Livestock Plaza/Sheep Barn

Addendum Issue Date: 8/8/24

The following changes, revisions, or clarifications shall be made to the drawing documents.:

Architecture | Planning | Interiors
434 5th St Suite 1
Brookings, SD 57006 | P: 605.692.4008
2301 W Russell St
Sioux Falls, SD 57104 | P: 605.692.4008

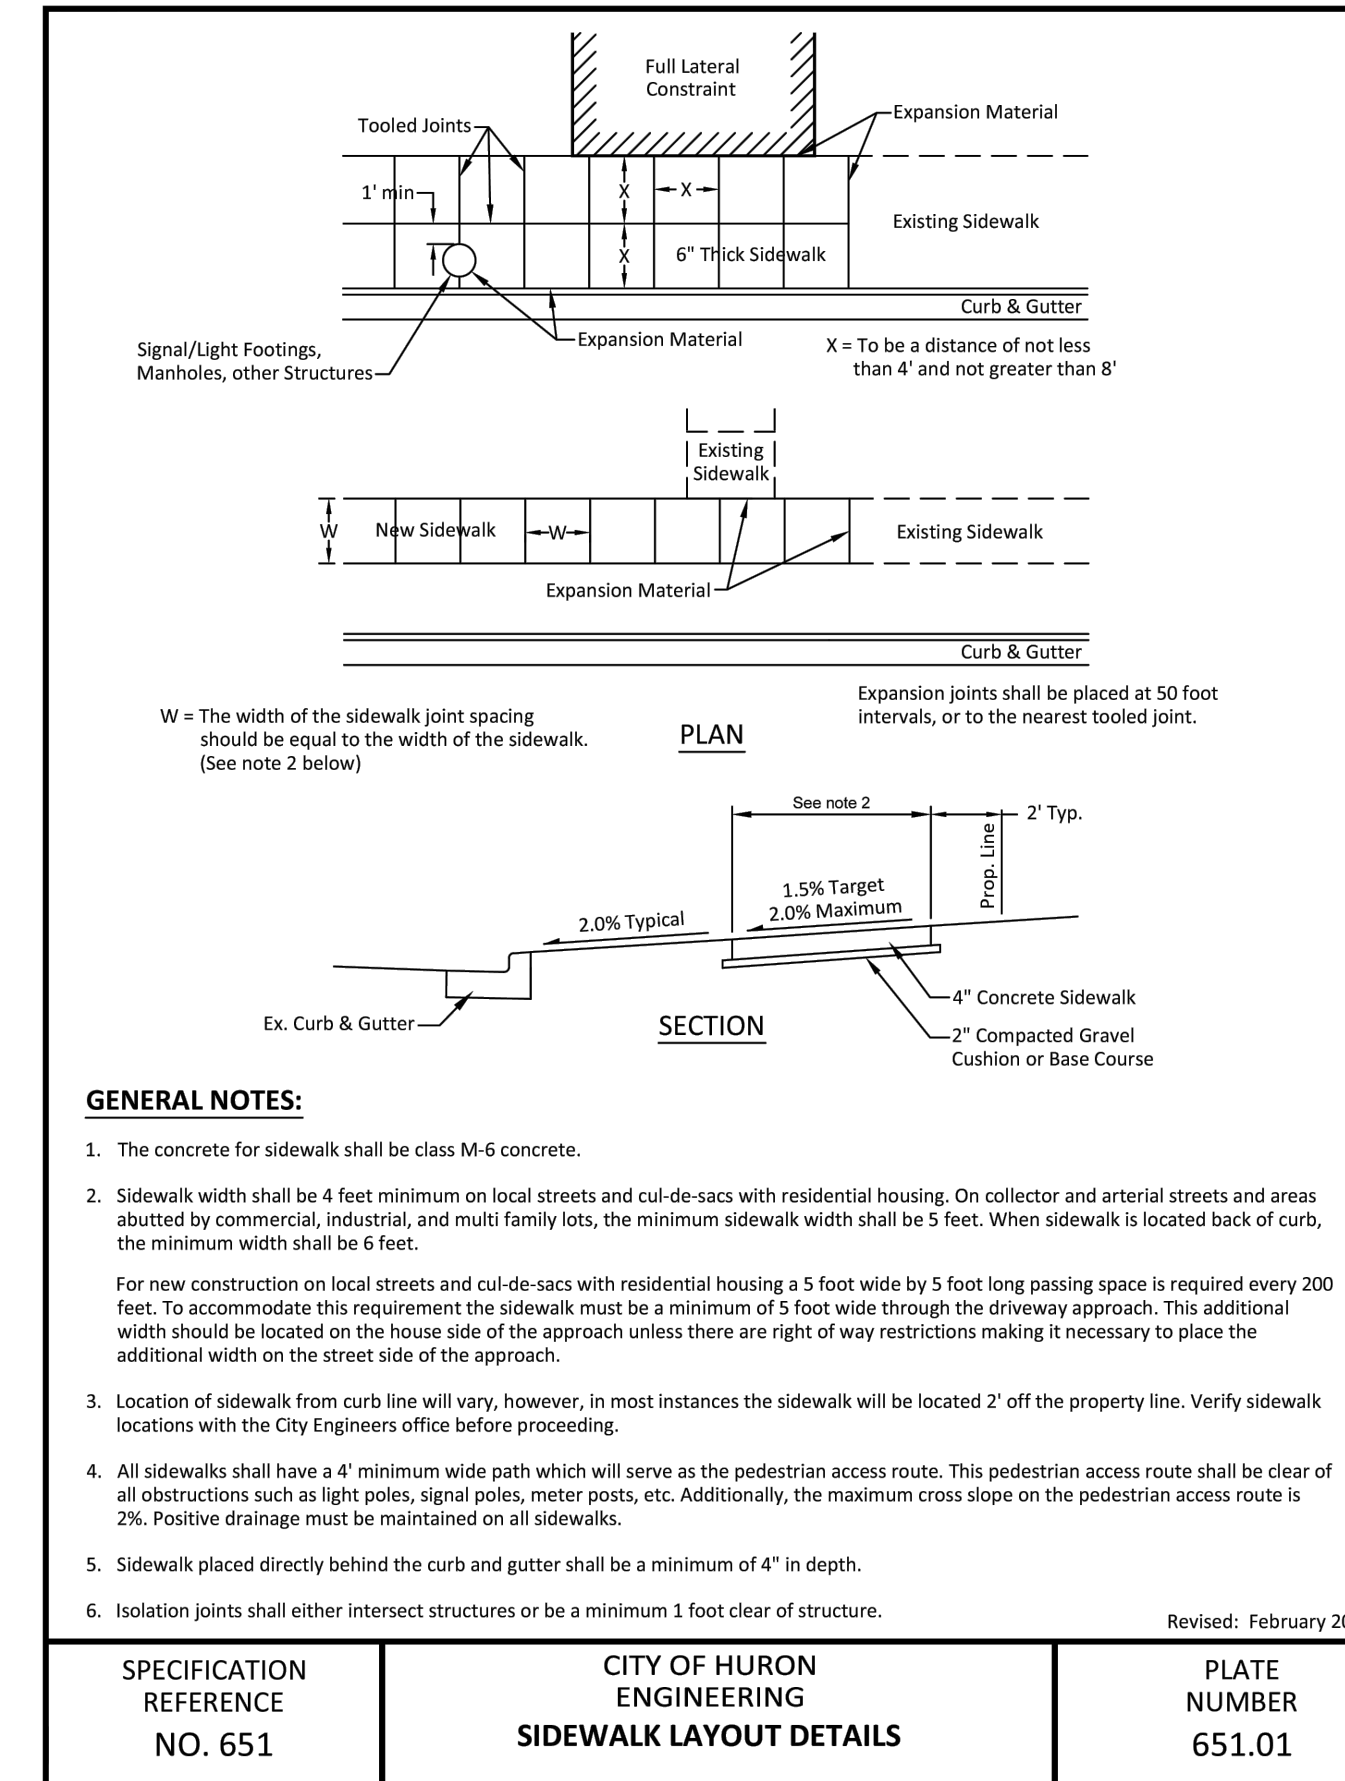
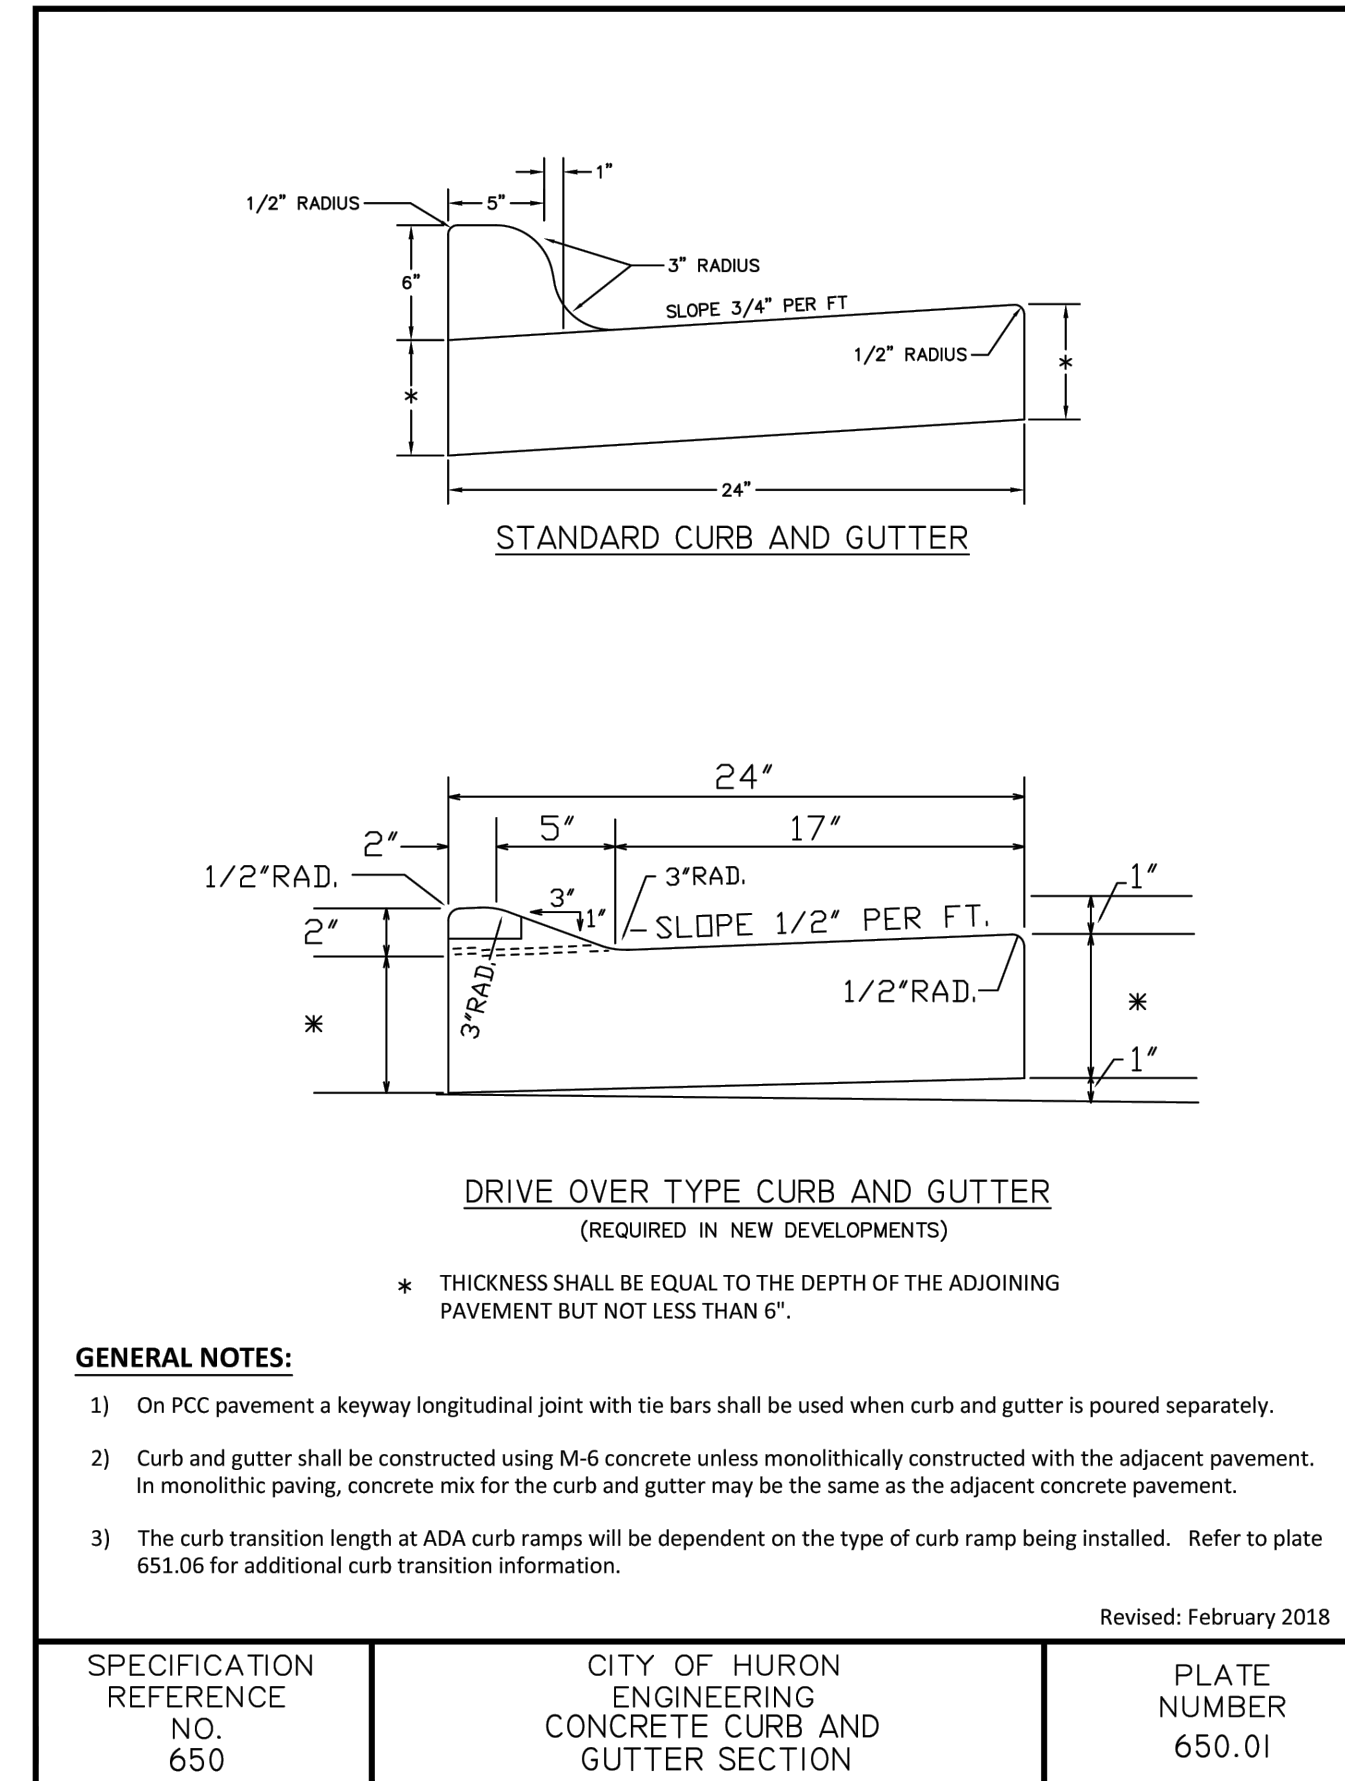
C3.1 - Quantities & Details

- Updated Quantities Tables

DEMOLITION PLAN

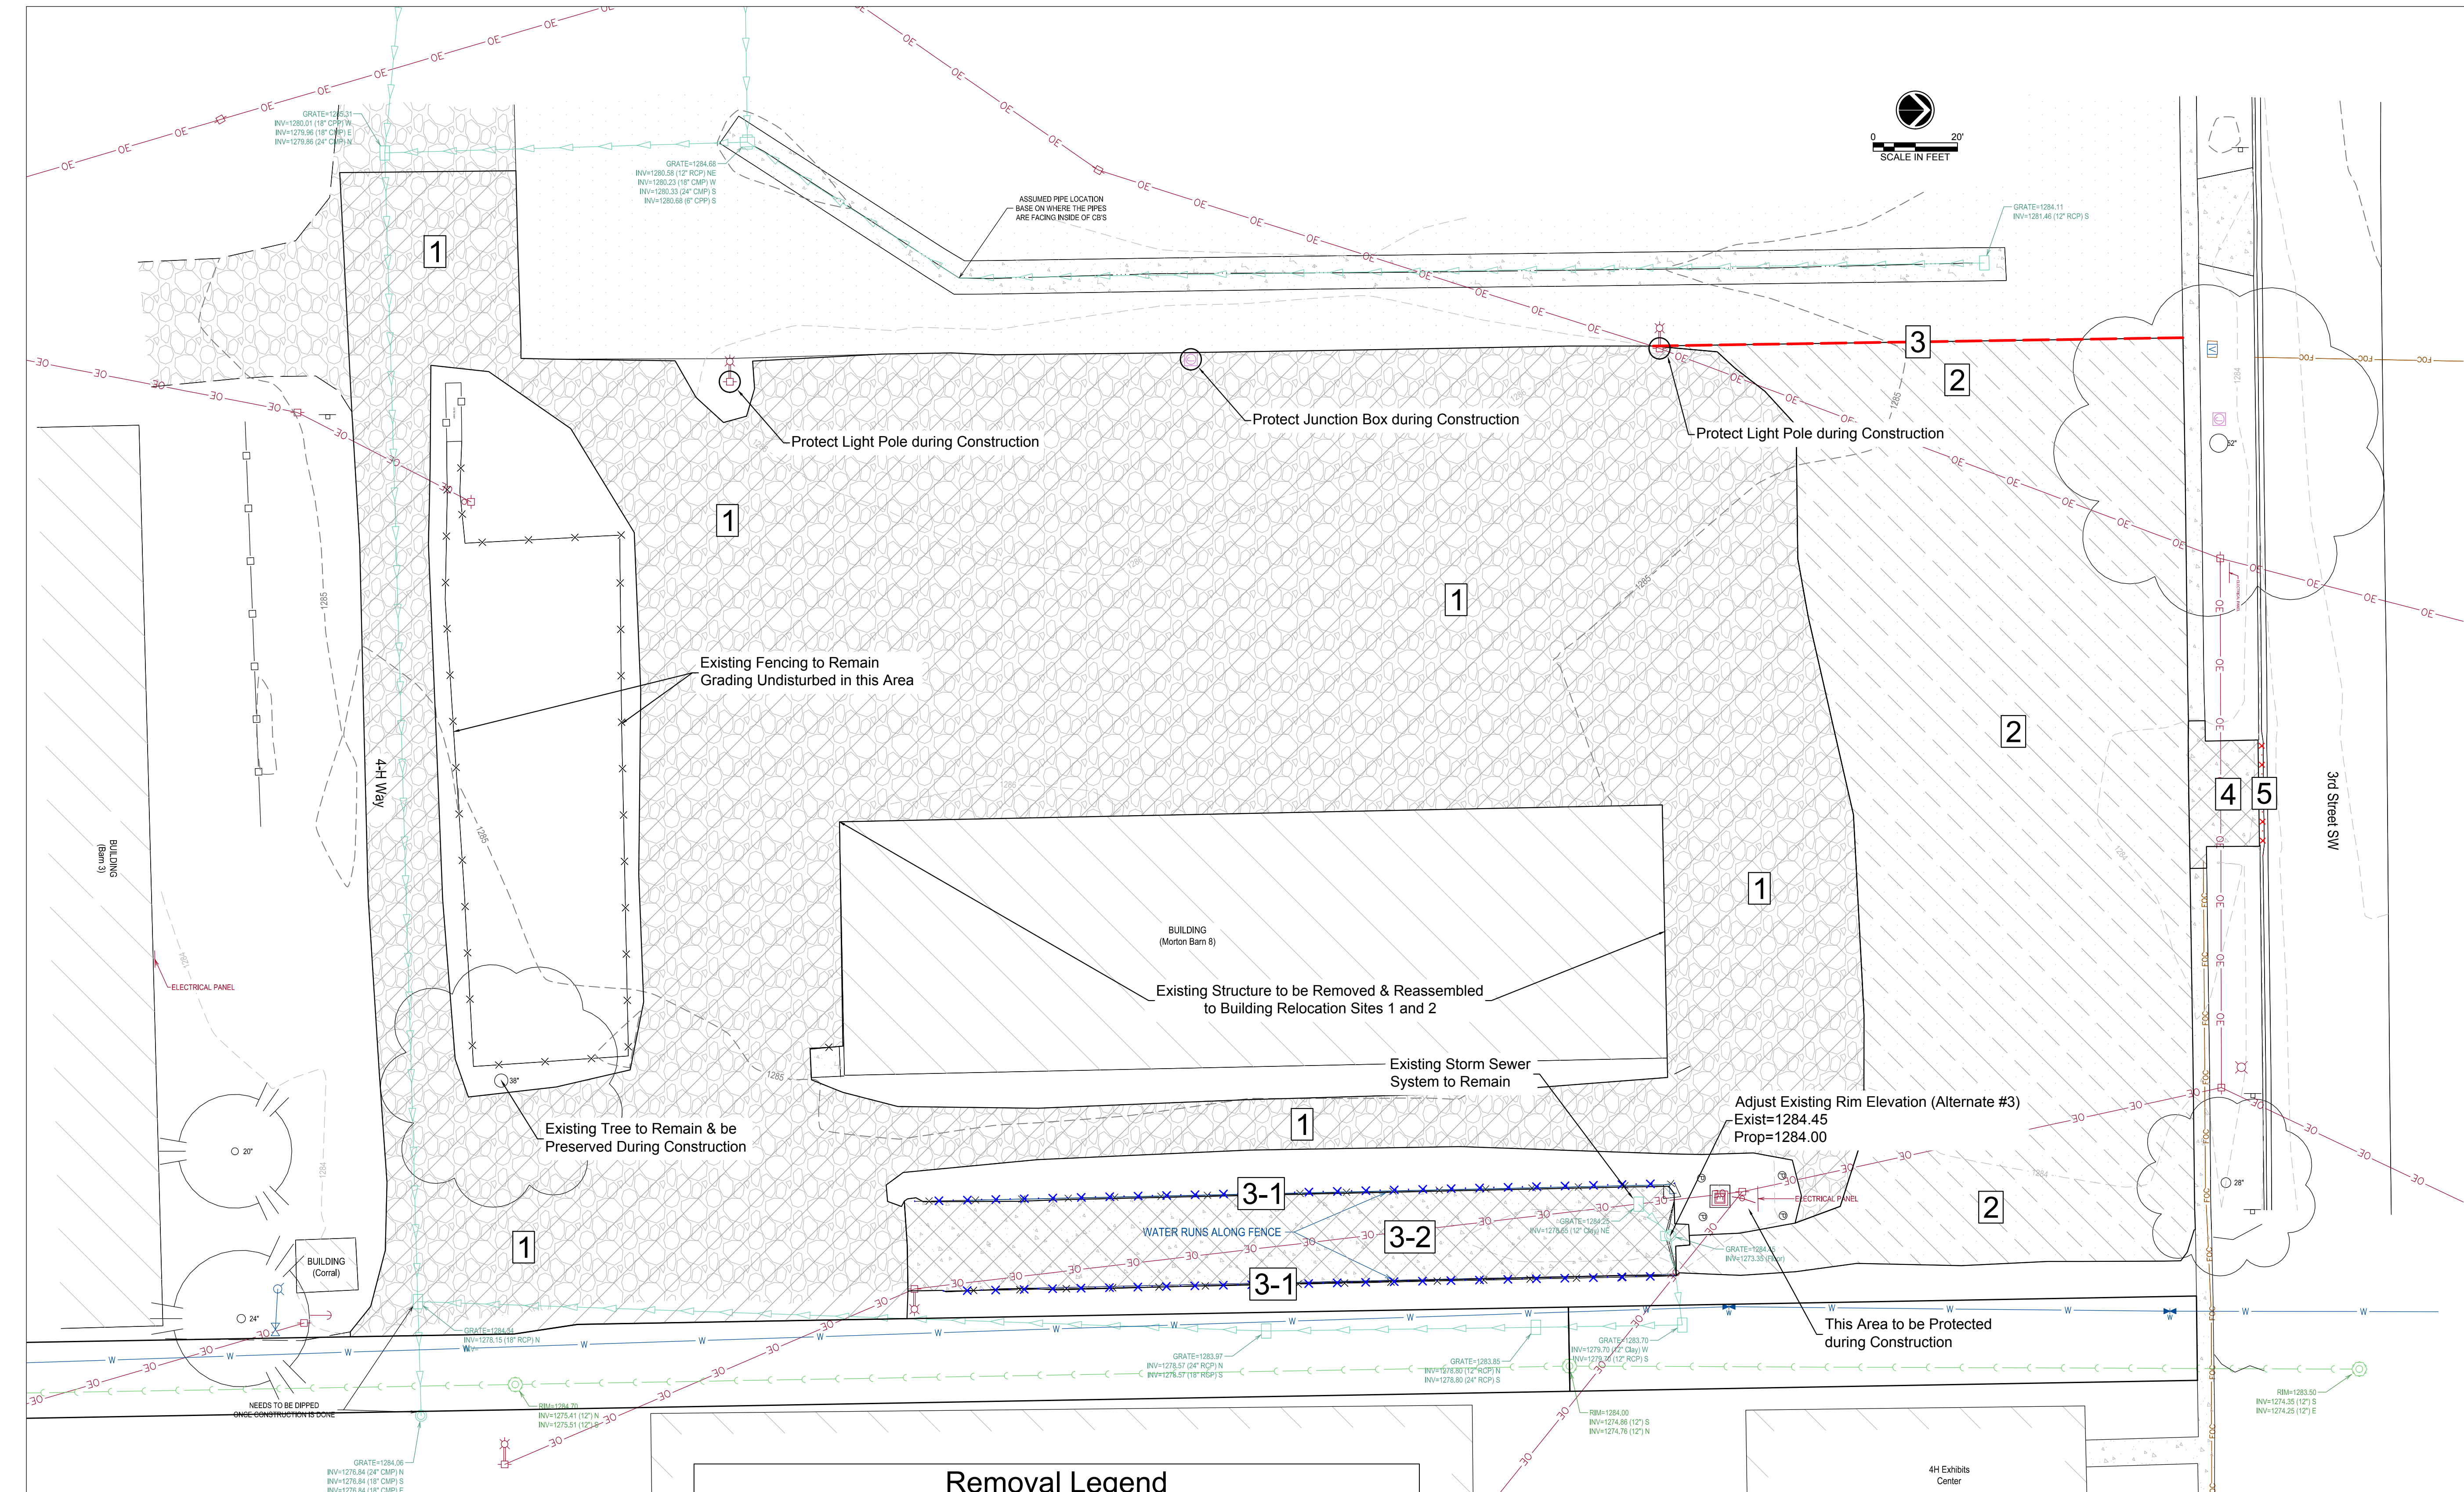
C4.1 - Demolition Plan

- Changed Adjust Existing Rim Elevation note to include (Alternate #3)
